Security of Supply Forecasting and Information Policy Review

Meridian appreciates the opportunity to provide feedback on the System Operator's consultation paper 'Security of Supply Forecasting and Information Policy (SOSFIP) Review – Draft amendment proposal' (*Consultation Paper*). Meridian's submission is comprised of this letter and an accompanying expert report by Dr Brent Layton, former Chair of the Electricity Authority.

Figure 1: Decadal distributions of Waiau storage

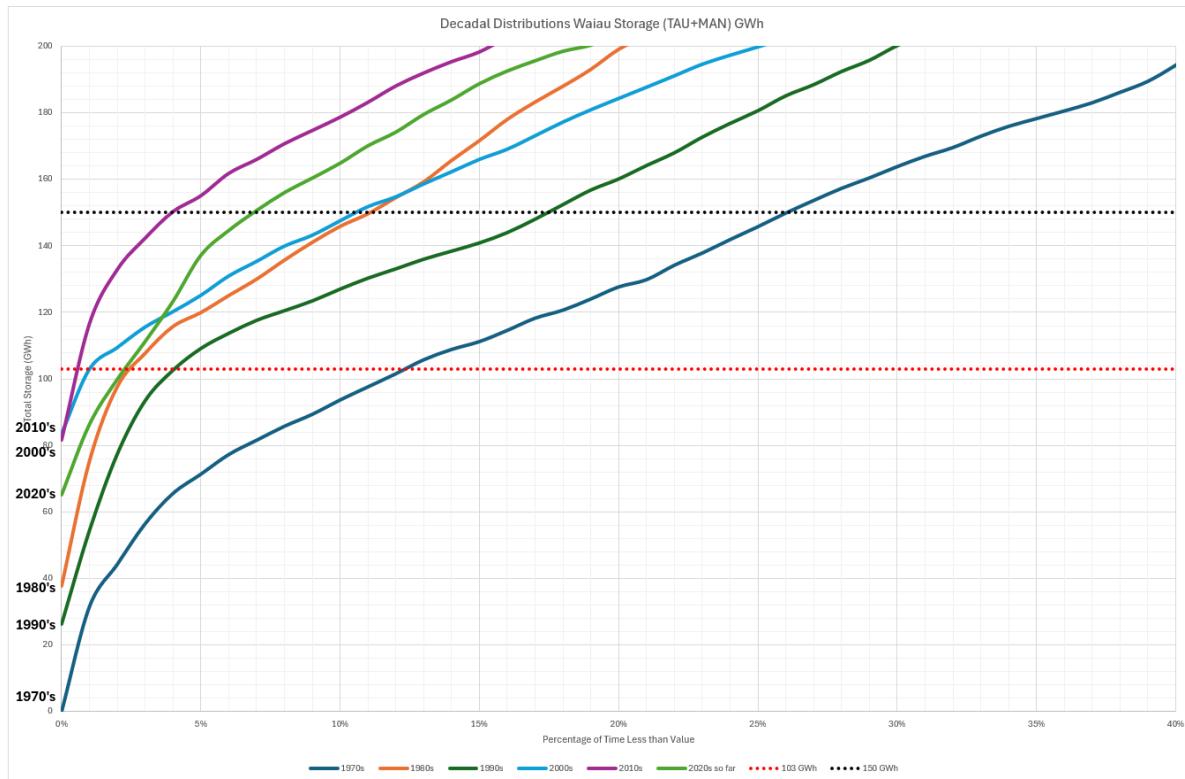
If historical operating levels are to be used as a reference point for setting the buffer, it is important to recognise that operation of these lakes has changed over the last 45 years. To illustrate this, Meridian has analysed the time spent at various storage levels in Lakes Manapouri and Te Anau by decade. The results of this analysis are shown in Figure 1 below.

This analysis makes clear that operation of Lakes Manapouri and Te Anau was quite different between the 1970s and 1990s than between the 2000s and 2020s, with the latter period seeing a much more conservative use of low range storage. This is likely driven by a combination of factors including changes in transmission, load, ownership and portfolios, as well as the creation of the electricity market itself.

If the System Operator chooses to use historical operating levels as a basis for determining an adjustment to the Alert CSRB buffer, it should do so on a forward-looking basis, which would mean only drawing on more recent historical usage patterns which are likely to be more reflective of current and future behaviours. Our view is a buffer adjustment of at least 103 GWh would be more reflective of the recent management of the Waiau lakes and ongoing constraints on operations.

Figure 2: Lake levels at Tekapo since 1992

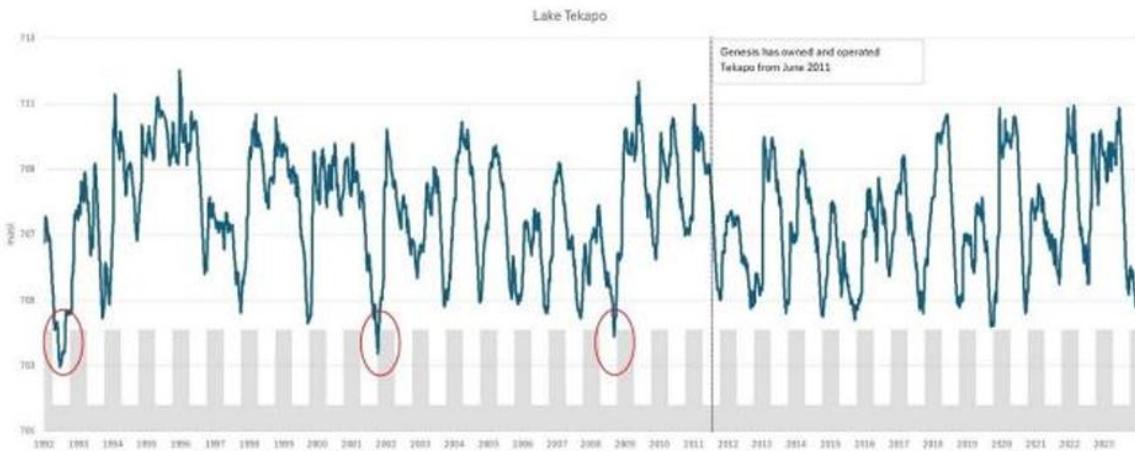
However, as illustrated in Figure 22 in the consultation paper (copied below as Figure 2), Genesis has never operated Lake Tekapo at below 220 GWh. This is despite dry years in 2012, 2021 and 2024.

Genesis's conservative operation of Lake Tekapo may be partly explained by a general risk aversion aimed at ensuring compliance with its resource consents. However, it is also the case that Genesis, as the owner and operator of the Huntly power station, has commercial incentives to maintain Tekapo lake levels in order to defer wider access to contingent storage and maximise use of its thermal plant as national storage starts to decline. That is, Genesis makes more money during a shortage situation when contingent storage is unavailable as this creates a greater need for generation from Huntly.

Based on Genesis' real-world behaviour and their commercial incentives to hold back access to contingent storage, we consider a fixed 220 GWh adjustment to the Alert CSRB buffer between April and September (as was adopted by the System Operator for Winter
